PROPOSED REVISION 15
AP1000 DESIGN CONTROL DOCUMENT

Tier 1 Subsection 2.2.5, Table 2.2.5-5, and Figure 2.2.5-1

Main Control Room Emergency Habitability System

Figure 2.2.5-1
Main Control Room Emergency Habitability System

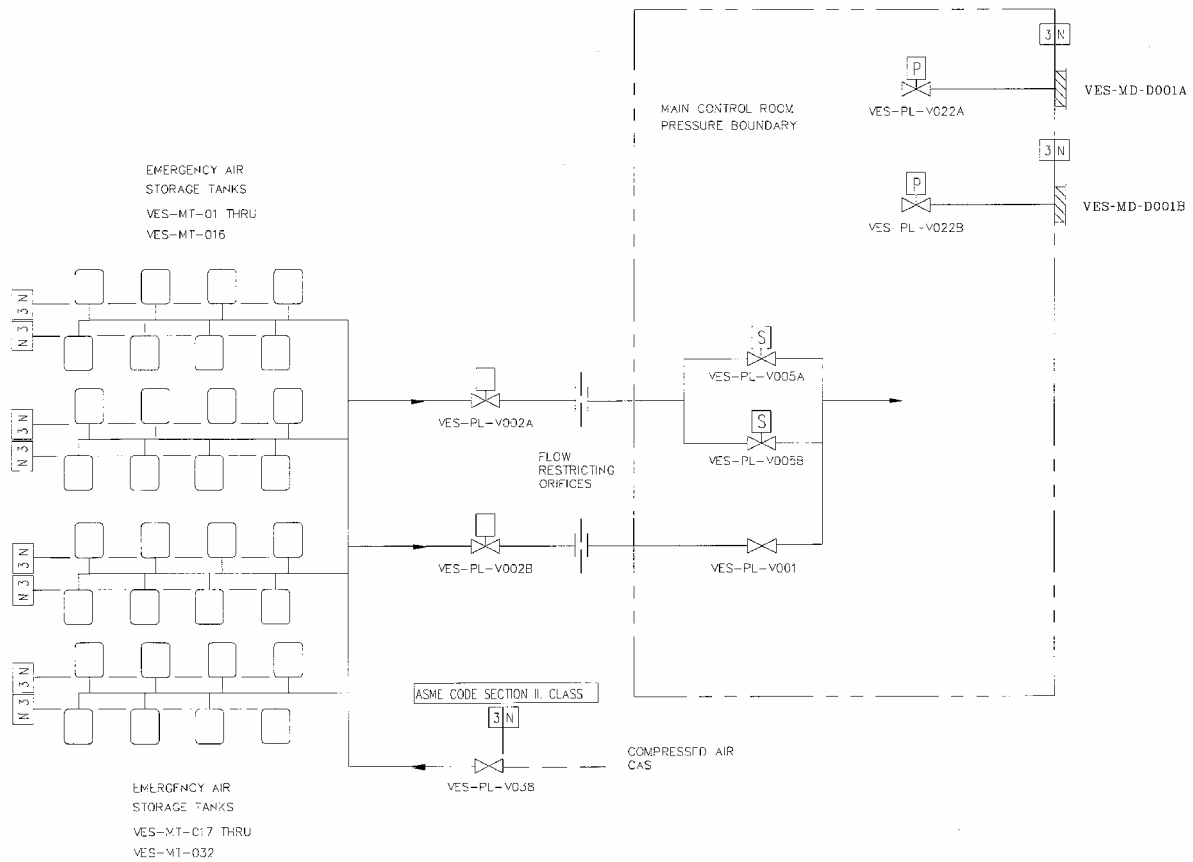
Correct certain tag numbers for equipment in the main control room emergency habitability system, and make a few additional editorial changes. Provide a precise reference for ITAAC item 6.b in Table 2.2.5-5.

Tier 1 Figure 2.2.5-1 Revise Tier 1 Figure 2.2.5-1 as shown on the next page.
